## REQUEST

Current Zoning: I-1, R-5, and R-17MF (light industrial, residential, multi-family residential)  
Proposed Zoning: UR-2 CD (urban residential, conditional)

Approximately 1.285 acres located along E. 16<sup>th</sup> Street and Louise Avenue in the Belmont neighborhood.

The petition proposes to rezone a multi-parcel assemblage in the Belmont community to permit a single-family attached residential community consisting of up to 24 units (~~18.67~~ 20.23 dwelling units per acre (DUA)).

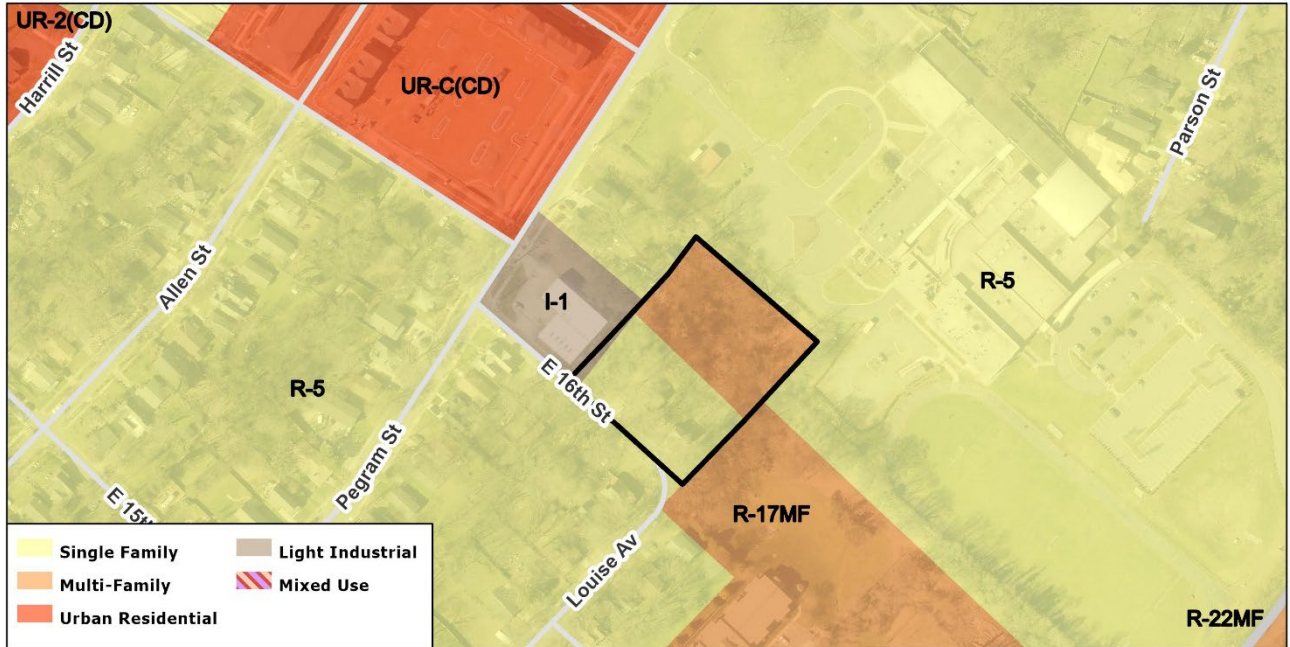
1. ~~Staff requests a commitment to match the architectural treatments of the end units facing public ROWs with the overall design of the units located in Building 3 (and conceptually illustrated on the rezoning site plan). Not providing that level of detail means an end unit would likely only be treated by windows to satisfy the limitation of blank wall expanses and lack other details (stoops, etc.) that Building 3 will have.~~ **ADDRESSED**
